SUBJECT: WNP-2- ISSUANCE OF AMENDMENT RE: PRESSURE TEMPERATURE LIMITS (TAC NO. MA5307)

The amendment revises TS 3.4.11, "RCS Pressure and Temperature (PT) Limits."

Amendment No. 159
License No. NPF-21

SAFETY EVALUATION BY THE OFFICE OF NUCLEAR REACTOR REGULATION

Figure 3.4.11-1 (Page 1 of 1)
Inservice Leak and Hydrostatic Testing Curve

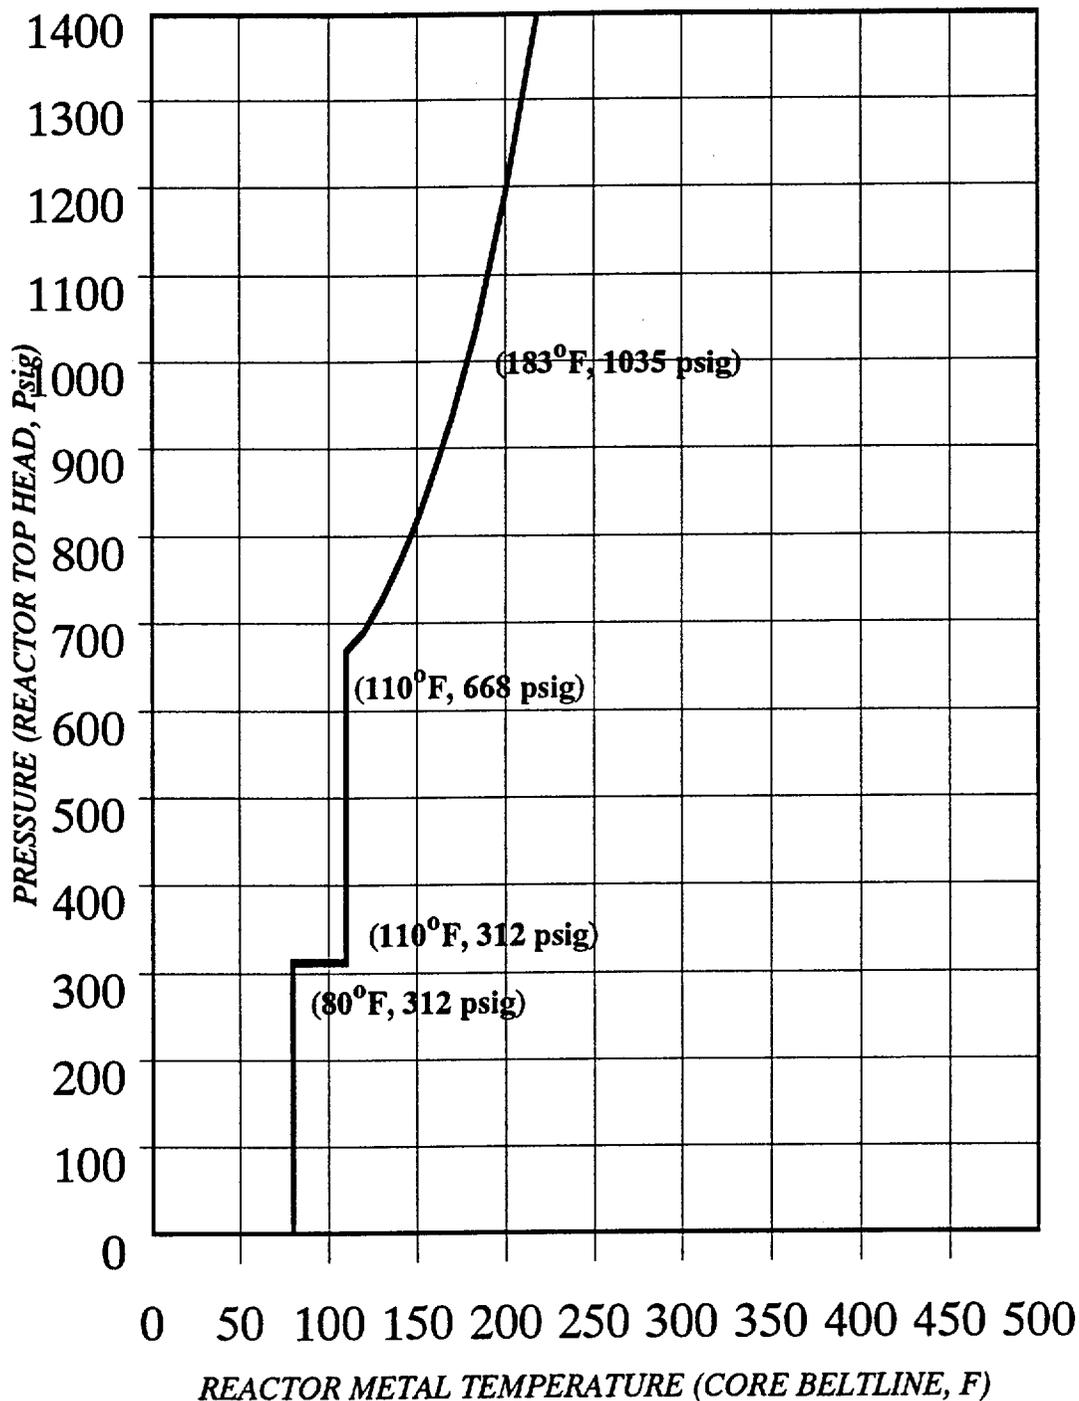
By application dated April 20, 1999, as supplemented by letter dated September 9, 1999, Energy Northwest (the licensee, formerly known as Washington Public Power Supply System) requested changes to the Technical Specifications (TSs) (Appendix A to Facility Operating License No. NPF-21) for WNP-2. The proposed changes would revise the WNP-2 pressure and temperature (P-T) limits for 32 effective full power years (EFPY) using the latest vessel beltline material and fluence data.

Substituting the ART of 79.2°F at 1/4T for the cooldown and 53.1°F at 3/4T for the heatup into equations in SRP Section 5.3.2, the staff could not verify the proposed P-T limit curves. In its response dated September 9, 1999, to the staff's request for additional information, the

licensee provided its detailed P-T limits methodology. This information revealed that for the nuclear heatup and cooldown curve, the licensee has added 40.0°F over the ASME Appendix G limits. In addition, the licensee has added 30.0°F to account for the difference between the fluid temperature and the 1/4T metal temperature. The staff determined that it is not necessary to consider this 30.0°F in the proposed P-T limits because the temperature axis of the licensee's proposed P-T limits is the 1/4T metal temperature of the RPV wall (confirmed in the licensee's supplement dated September 9, 1999), which is the same as the temperature used in the fracture toughness (K_{Ia}) equation in the ASME Appendix G methodology. After consideration of the additional conservatism of 30.0°F in the licensee's proposed P-T limits (for 32 EFPY), the staff agrees with the proposed P-T limits for heatup, cooldown, and hydrotest, and concludes that the proposed P-T limits meet the beltline material requirements in Appendix G of 10 CFR Part 50.

The staff concludes that the proposed P-T limits for the reactor coolant system for heatup, cooldown, leak test, and criticality are valid as indicated on the curves. The P-T limits satisfy the requirements of Appendix G of 10 CFR Part 50 for 32 EFPY. The proposed P-T limits also satisfy GL 88-11 because the method in RG 1.99, Rev. 2, was used to calculate the ART. Hence, the proposed P-T limits may be incorporated into the WNP-2 TSs.

Figure 3.4.11-3 (Page 1 of 1)
Nuclear Heating and Cooldown Curve

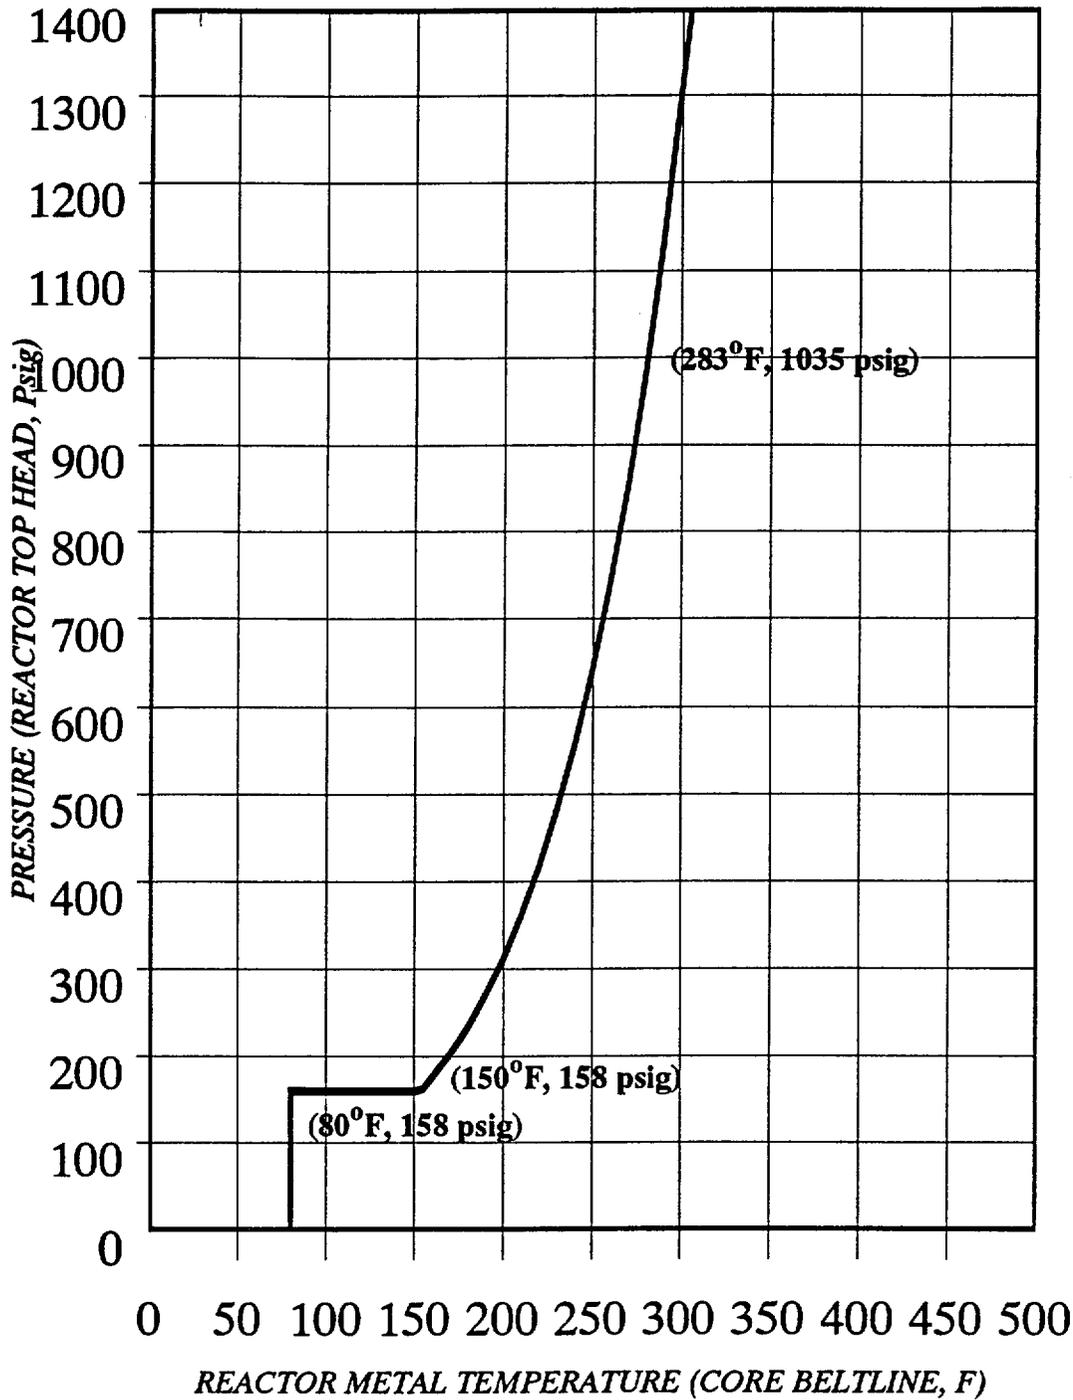
In addition to beltline materials, Appendix G of 10 CFR Part 50 imposes P-T limits based on the reference temperature for the reactor vessel closure flange materials. Section IV.A.2 of Appendix G states that when the pressure exceeds 20 percent of the preservice system hydrostatic test pressure, the temperature of the closure flange regions highly stressed by the bolt preload must exceed the reference temperature of the material in those regions by at least 120°F for normal operation and by 90°F for hydrostatic pressure tests and leak tests. Based on the flange limiting material reference temperatures of 20°F, the minimum allowable temperature of this region is 110°F (20°F+90°F) as indicated by the straight line of 110°F of the hydrostatic testing curve. The 80°F line appearing in the P-T limits for all conditions is in accordance with item 2e of Table 1 of Appendix G of 10 CFR Part 50, which requires a minimum temperature of 60°F be added to the flange limiting material reference temperature of 20°F. Hence, the staff has determined that the proposed P-T limits satisfy the requirements in Section IV.A.2 of Appendix G of 10 CFR Part 50.
